City of Corpus Christi

Meeting Agenda

Planning Commission

Wednesday, October 28, 2020

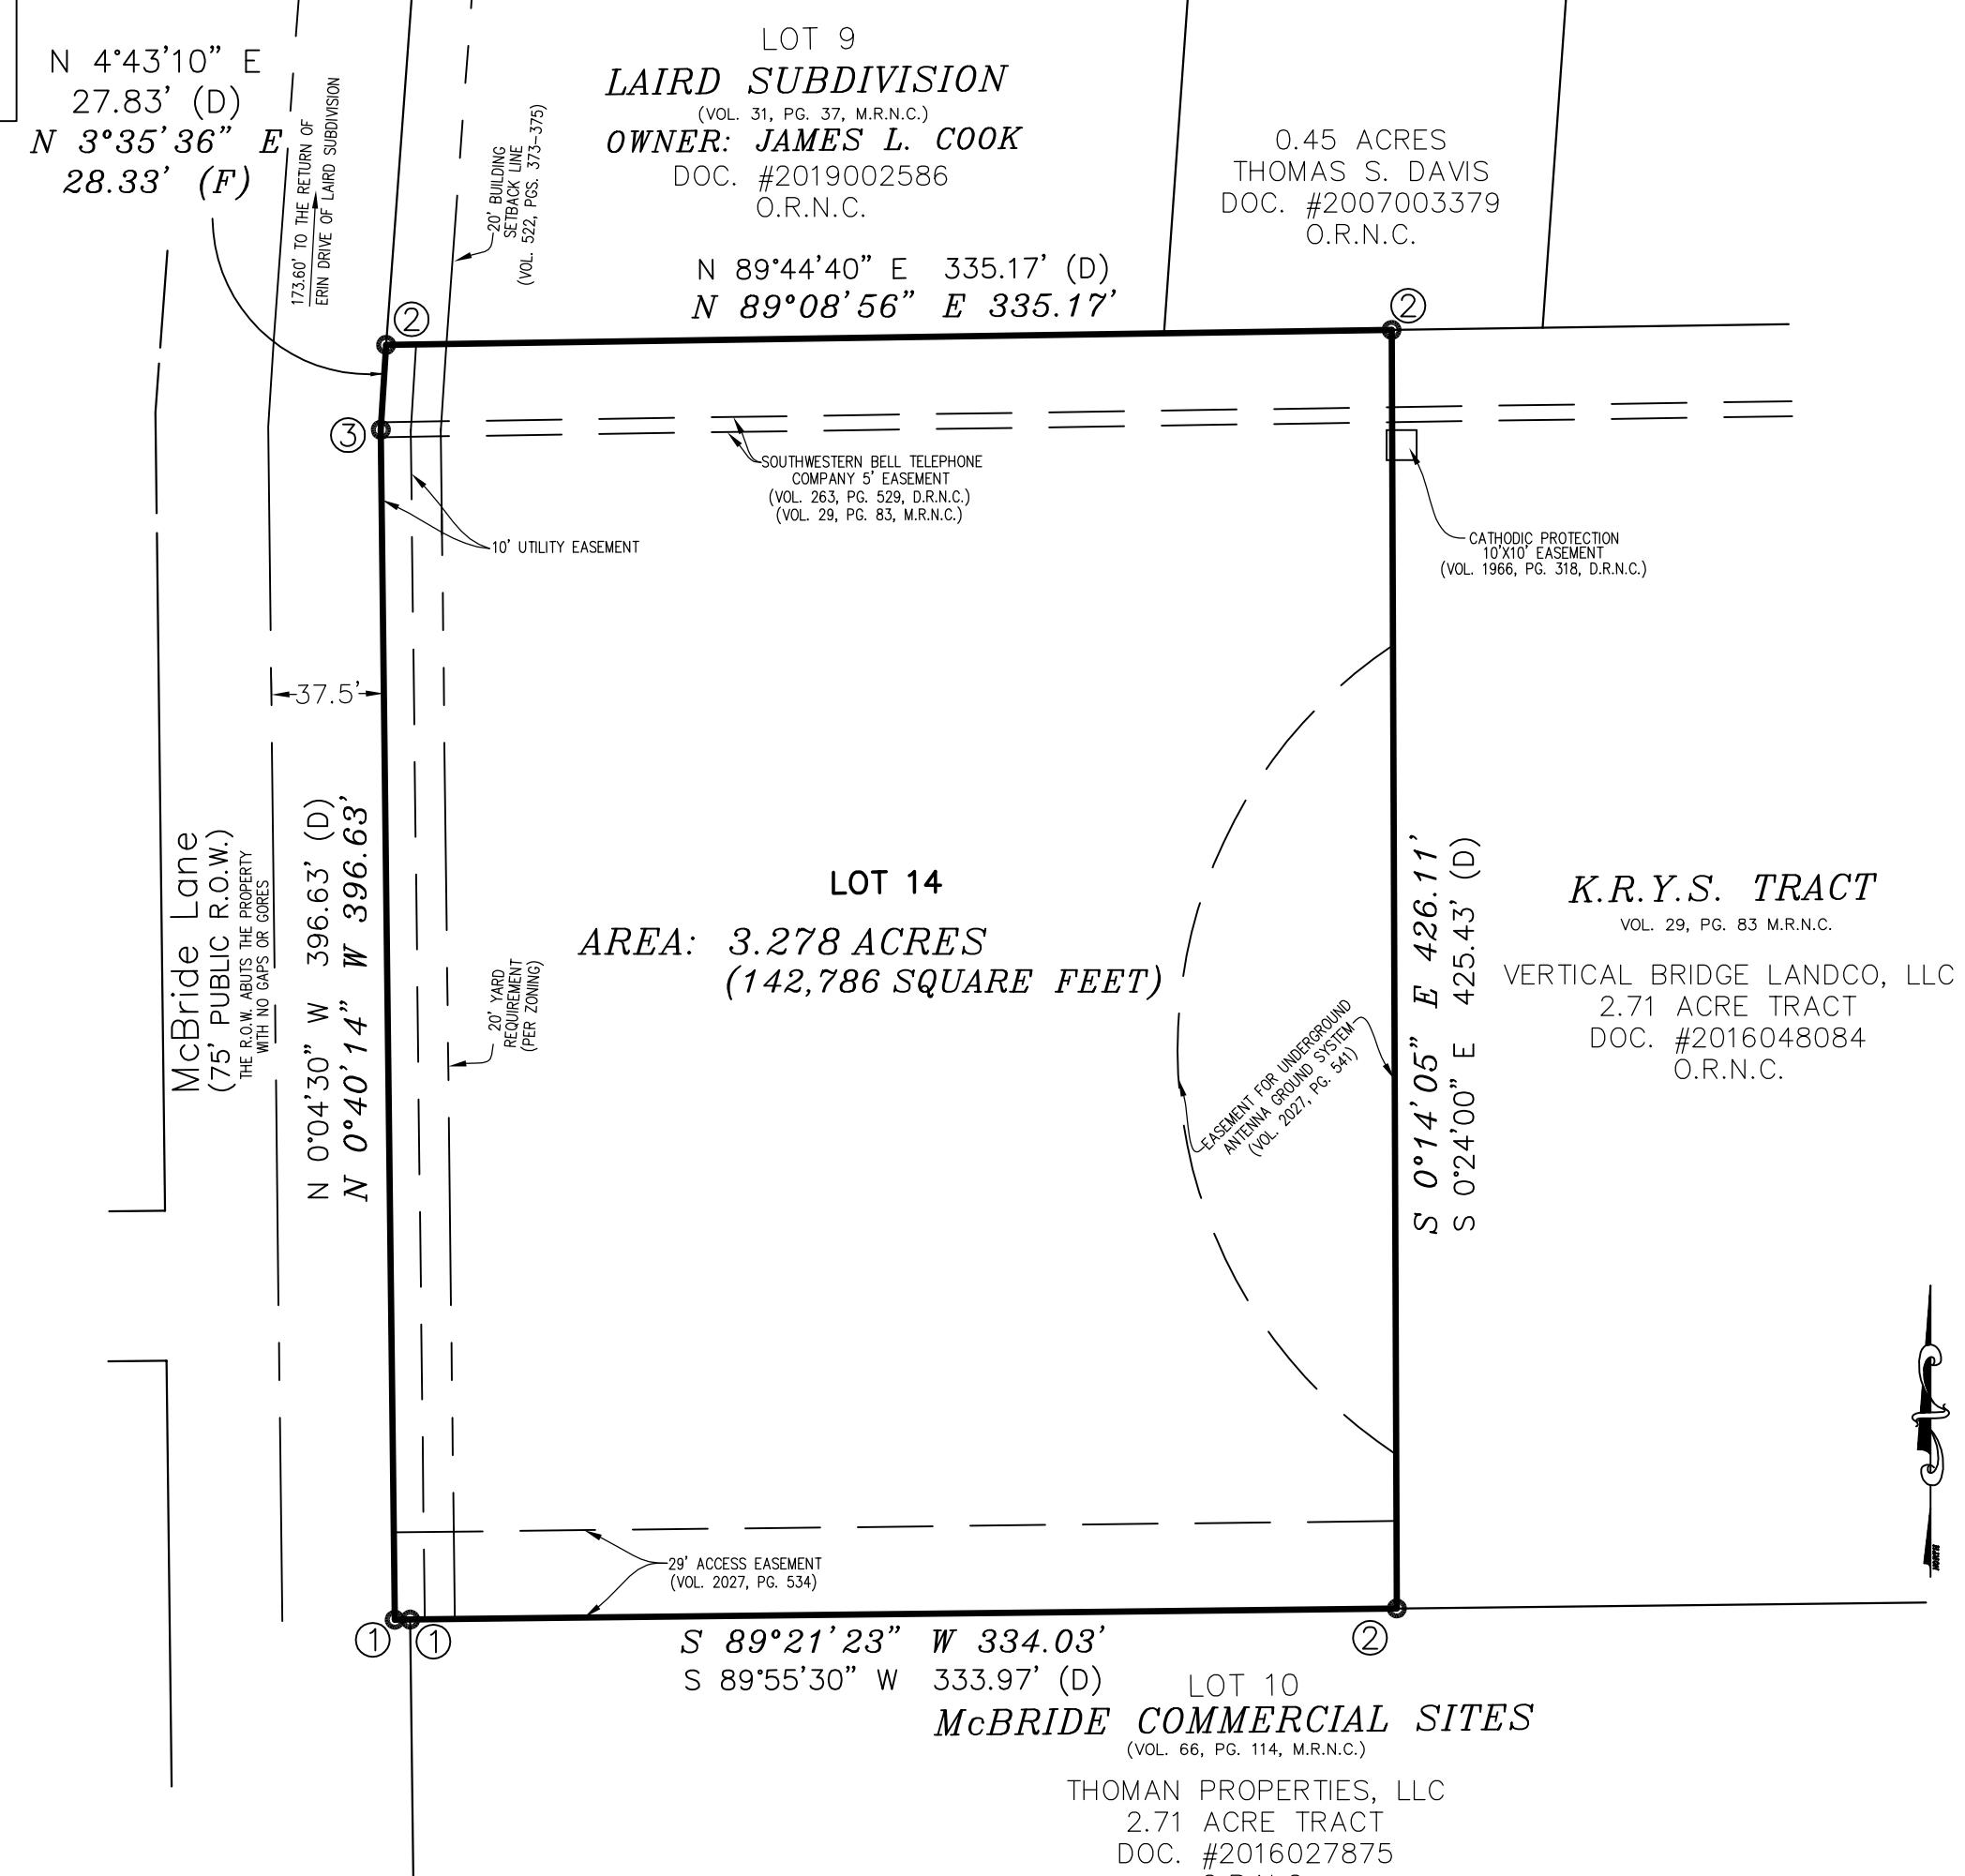
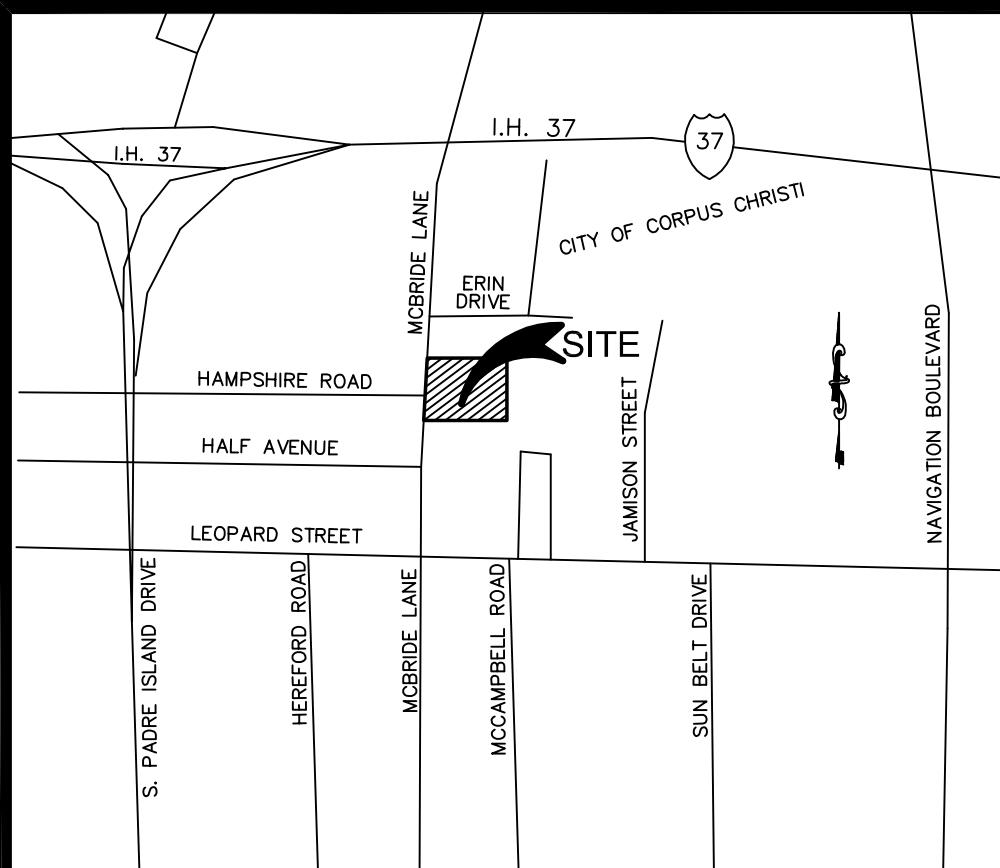
GIS						
No.	Sheet	Comment	Applicant Response	Staff Resolution	Applicant Response	Staff Resolution
1	Plat	The plat closes within acceptable engineering standards.	Plat does close.	Resolved		
2	Plat	Plat title should stand out from platted area. Revise the legal description to _____, Block _____, Lots _____.	Plat title updated	Resolved		
3	Plat	Please remove zoning designation from lots.	Zoning removed	Resolved		
4	Plat	Label the required yard requirement lines not shown on the plat.	Yard requirement provided	Resolved

LAND DEVELOPMENT						
No.	Sheet	Comment	Applicant Response	Staff Resolution	Applicant Response	Staff Resolution
1	Plat	Provide acreage and square footage underneath Lot label.	Added acre & square footage	Addressed.		
2	Plat	Remove the zoning designation from the platted area.	Zoning removed	Addressed.

3	Provide Notary certificate for Owners certificate.	Notary added	Not Addressed. Certificate not provided listing verification of Owner (Printed). Owners certificate to have printed name of authorized person, James King?		To be addressed prior to recordation
4	Provide complete legal descriptions of adjacent properties.	adjacent legal description added	Addressed.		
5	Verify existing width of right of way. Provide half distance from centerline to boundary of property.	Distance to centerline provided	Addressed.		
6	Zone C flood designations are not required to have elevations contours on the plat.	Contours removed	Addressed.		
7	DS Engineer is Jalal Saleh, PE.	DS Engineer name added	Addressed.		
8	Label the 20' YR (Yard Requirement) on plat.	Yard requirement added	Not Addressed. Change BL to Yard Requirement (YR).		Addressed.
9	Provide a 10' UE (Utility Easement) along McBride Lane frontage.	10' UE added	Addressed.

10	Move plat title to top of page. Increase text size of name of Plat. Lot number to be under title. Remove city and county under plat title.	Plat title moved, text of name of plat increased in size, Lot number added under title, removed city and county under plat title.	Not Addressed. Plat description to be under Plat Title. Remove from title, "Replat Establishing" and leave on plat description.		Addressed.
11	Plat notes to be consistent with other text on plat.	Updated	Addressed.		
12	Enlarge location map and provide larger text size for streets.	Enlarged	Addressed.

DEVELOPMENT SERVICES ENGINEERING						
No.	Sheet	Comment	Applicant Response	Staff Resolution	Applicant Response	Staff Resolution
1		Public Improvements Plans are required; submit a pdf copy of proposed public improvements along with a title sheet to PublicImprovements@cctexas.com for review and approval; this item is required prior to Final Plat Recordation. UDC 8.1.3.A	It is anticipated that 1 fire hydrant is required to protect existing/proposed building(s). It is proposed to be at the front of the site.	To be addressed prior to recordation.		
2	Plat	Add the following receiving water note to the plat "The receiving water for the storm water runoff from this property is the Corpus Christi Inner Harbor. The TCEQ has classified the aquatic life use for the Corpus Christi Inner Harbor as "intermediate".	Note added to plat.	Addressed.		
3	Utility Plan	Label the water along McBride Lane (8" ACP); label the wastewater along McBride Lane (24" VCP)	Water/Wastewater lines labeled.	Addressed.

UTILITIES ENGINEERING						
No.	Sheet	Comment	Applicant Response	Staff Resolution	Applicant Response	Staff Resolution
1	Plat	Water construction is required for platting. Install fire hydrant for fire protection.	It is anticipated that 1 fire hydrant is required to protect existing/proposed building(s). It is proposed to be at the front of the site.	To be addressed prior to recordation.		
2	Plat	No wastewater will be required for platting. However, the only connection available for this development is at the Manhole, at the intersection of Hampshire & McBride.	N/A	Addressed.
